**Sixth Interim Collection
1994–1996 NESC® Interpretations**

National Electrical Safety Code Committee, ASC C2

Abstract: This edition includes official interpretations of the National Electrical Safety Code as made by the Interpretations Subcommittee of the National Electrical Safety Code Committee, ASC C2.

Fig 490

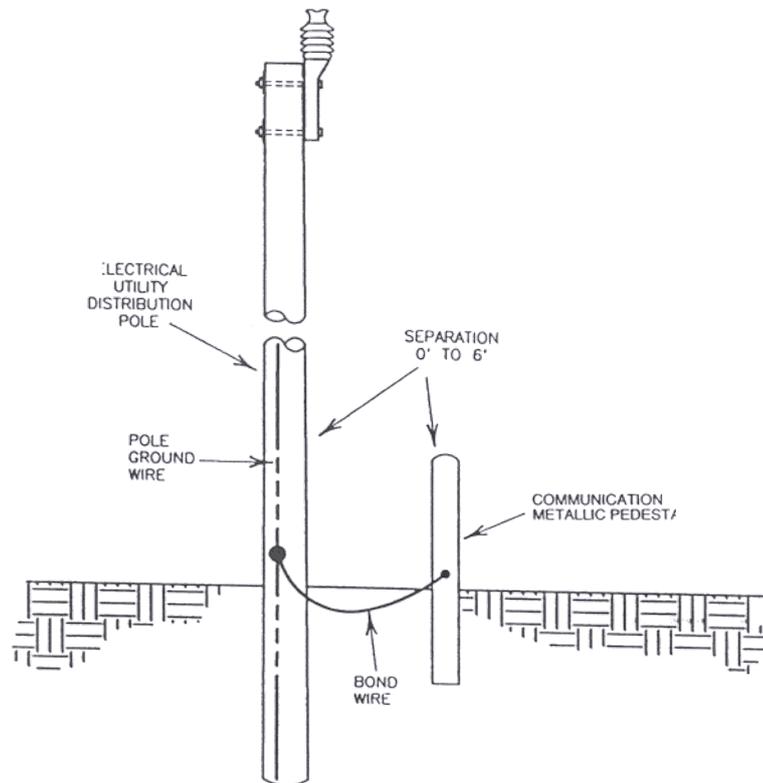
Rule 350F states "Bonding should be provided between all above ground metallic power and communications apparatus (pedestals, terminals, apparatus cases, transformer cases, etc.) that are separated by a distance of 6 ft (1.80 m) or less."

The attached drawing (Fig IR 490) shows an above ground communications apparatus (pedestal) within 6 ft of a power utility pole with a metallic ground wire. Does this ground wire constitute a metallic power apparatus and, as such, would bonding between the ground wire and communications apparatus be required under Rule 350F?

Rule 350F does not require bonding between a vertical ground wire on a pole (pole ground) and a communication pedestal, even though they are 6 ft or less apart. While *apparatus* does not appear in the NESC definitions, the parenthetical listing of pedestals, terminals, apparatus cases, transformer cases, etc., supplies the context of items to be bonded under Rule 350F. This listing was not intended to include conductors. The "pole ground wire" shown in your drawing is a conductor (see definitions); it is not included in the listing of items to be bonded.

Please note that Rule 350F does not prohibit bonding.
